SUBJECT: EXEMPTION AMENDMENT FROM CERTAIN TECHNICAL REQUIREMENTS OF APPENDIX R TO 10 CFR PART 50 - NORTH ANNA POWER STATION, UNITS NO. 1 AND NO. 2 (NA-1&2) (TAC NOS. M89192 AND M89193)

ADDENDUM TO EXEMPTION REQUEST # 1  
APPENDIX R REPORT  
NORTH ANNA POWER STATION

SAFETY EVALUATION BY THE OFFICE OF NUCLEAR REACTOR REGULATION  
LICENSEE REQUEST FOR ADDENDUM TO EXEMPTION FROM  
CERTAIN REQUIREMENTS OF APPENDIX R TO 10 CFR PART 50  
NORTH ANNA POWER STATION UNITS 1 AND 2  
DOCKET NOS. 50-338 AND 50-339

FIGURE NO.  
 1.3

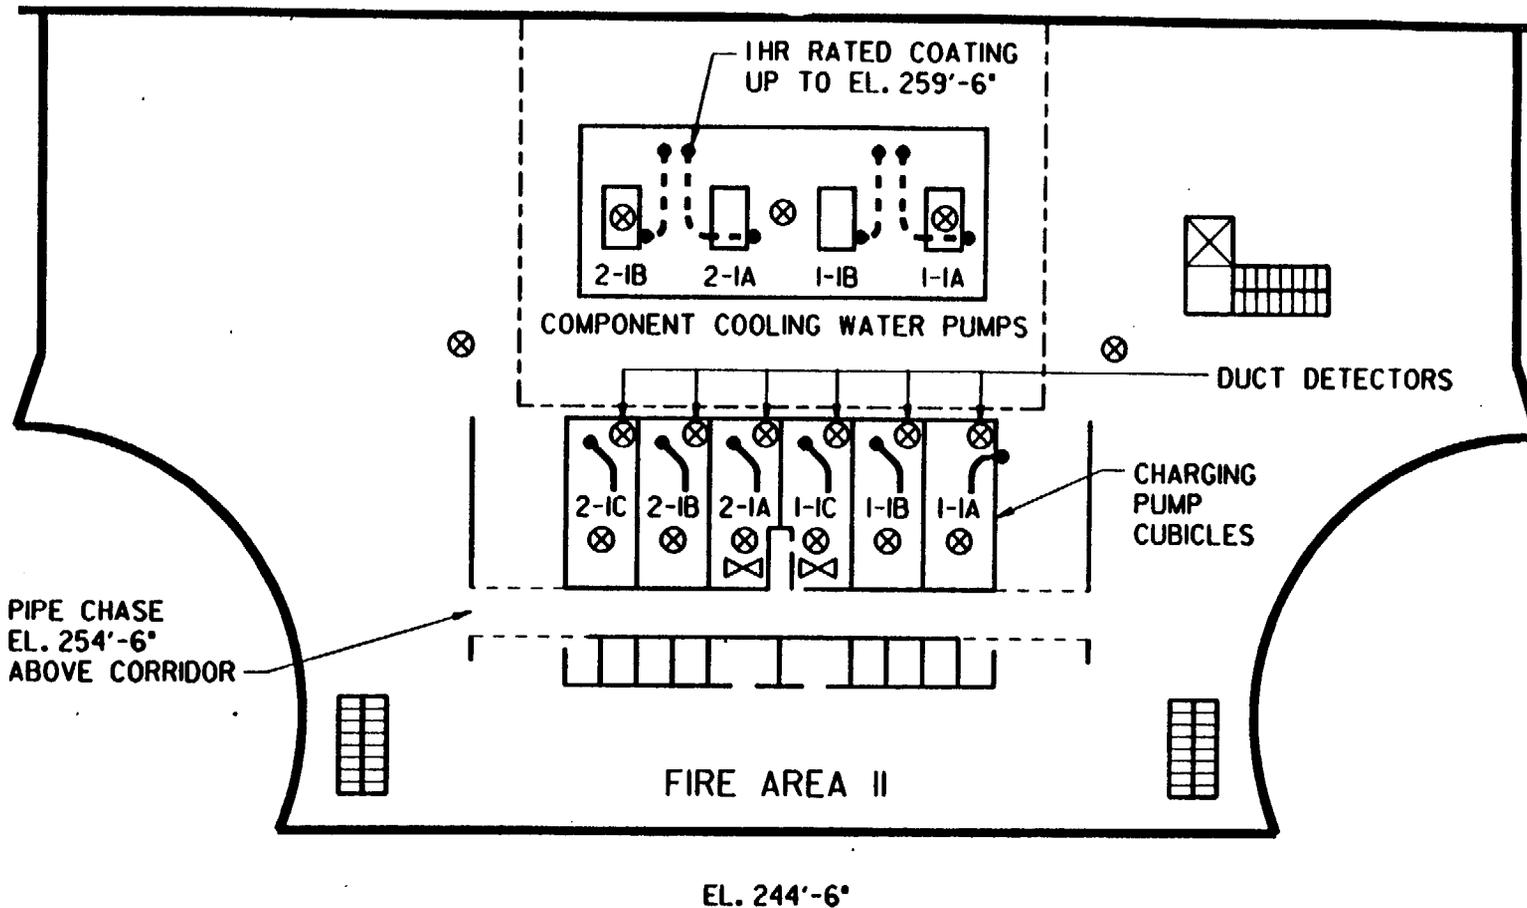
"The horizontal pipe chase is located south of the charging pump cubicles and extends along the south wall of each pump cubicle (See Figure 1.3). The pipe chase is open ended at the pipe penetration areas adjacent to the

Unit 1 and 2 Containments, and has openings into the adjacent cubicles (seal water filters, heat exchangers, ...etc.) located on the south side of the pipe chase. The vertical pipe chase is located between cubicles 2-1A and 1-1C and extends vertically to the Volume Control Tank (VCT). This vertical chase has an unsealed opening into cubicle 1-1C and is open ended at the VCT with no intermediate openings. The vertical and horizontal pipe chases are not expected to create a fire exposure to the cubicles due to the lack of combustible material in the chases. A fire in cubicle 1-1C would not be expected to enter the pipe chases due to the negligible amount of combustibles in the chases. If the fire did enter the chases, it would travel out and away from the adjacent cubicles which have penetrations sealed with metal plates."

2. Figure 1-3 is replaced with the revised Figure 1-3 (attached).
